2.5.4 Stability of Subsurface Materials and Foundations

SSAR Section 2.5.4 presents the applicant's evaluation of the stability of subsurface materials that underlie the VEGP ESP site. There are a total of 12 subsections within SSAR Section 2.5.4. Among them, Section 2.5.4.1 does not contain any specific details, but refers to SSAR Sections 2.5.1.1 and 2.5.1.2 regarding regional (within a 320-kilometer (km) (200-mile (mi)) radius) and site area (within an 8-km (5-mi) radius) geology and tectonics for the ESP site. Section 2.5.4.9 cross-references SSAR Sections 2.5.2.6, 2.5.2.7, and 2.5.2.8 for determination of the SSE and operating-basis earthquake (OBE). Section 2.5.4.2 describes the engineering properties of the subsurface materials. Section 2.5.4.3 describes subsurface explorations performed at the ESP site, and Section 2.5.4.4 describes geophysical surveys performed by the applicant to determine shear and compressional wave velocities of the soil and rocks beneath the ESP site. Section 2.5.4.5 describes excavation and backfill work for the ESP site. Section 2.5.4.6 describes local ground water conditions. Section 2.5.4.7 describes site-specific shear wave velocity profile, she

**Figure 2.5.4-10 - Settlement of Typical Foundation
(Reproduced from SSAR Figure 2.5.4-14)**

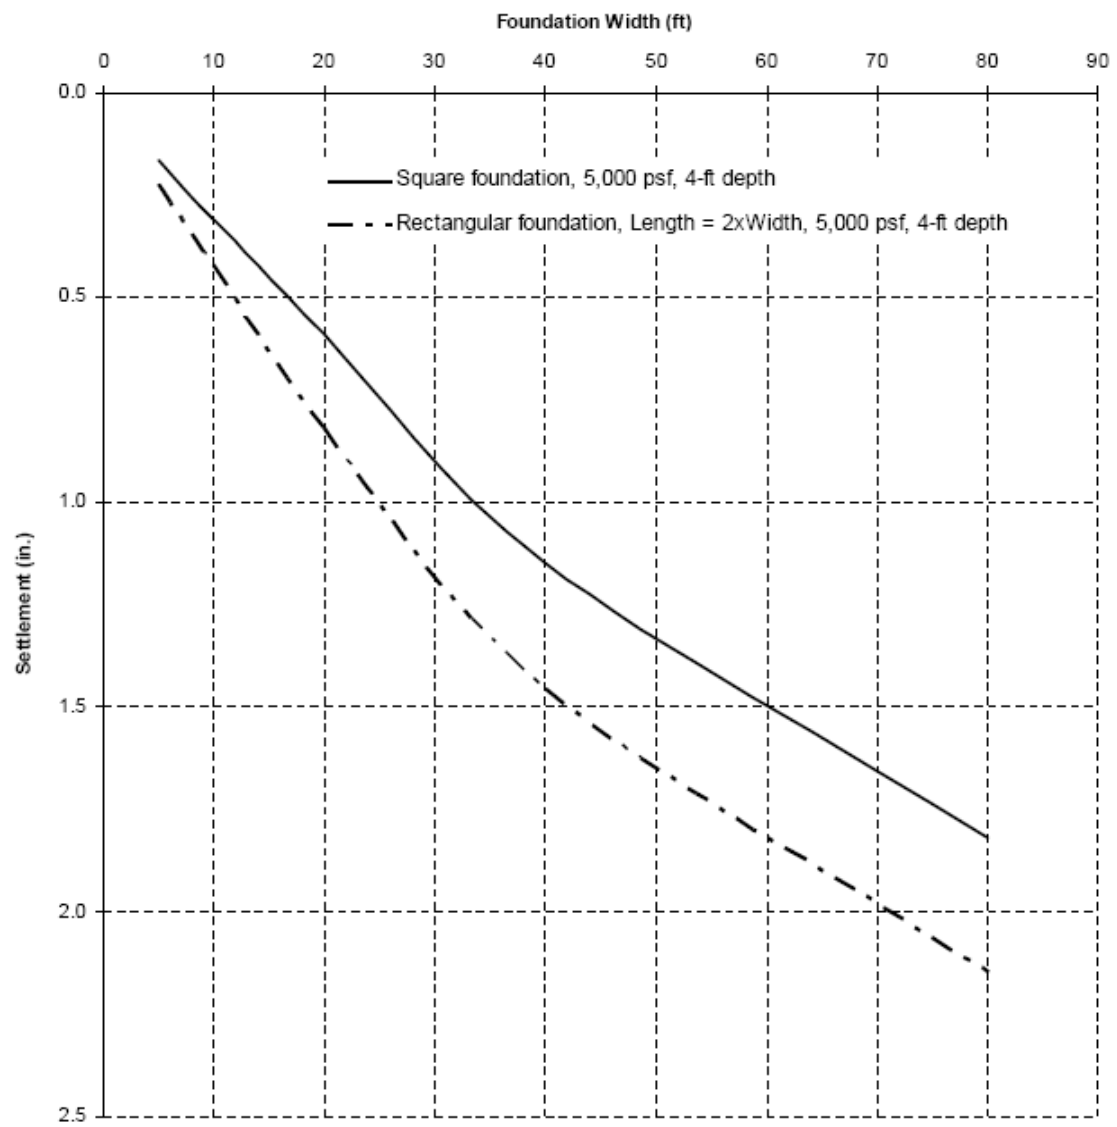
1. A primary concern of potential total and differential settlements is how these settlements compare with what the design of the reactor takes into consideration. It is important to compare the estimated settlements, which are appropriate for evaluation of the acceptability of the site at the ESP stage, with those incorporated into the plant design to evaluate the degree of conservatism because there will be severe impact to the safety of the SSCs once unexpected differential settlements occur.
2. The contact pressures associated with the planned reactor model are of interest and need to be considered at the ESP stage to estimate potential settlement. Since the data for a given reactor facility are available, the applicant should incorporate it into the site evaluation.

differential). The applicant did not provide a detailed settlement analysis to ensure that the SSCs for a particular reactor model or envelope of various models (in the case that no definitive model is selected) are safe.
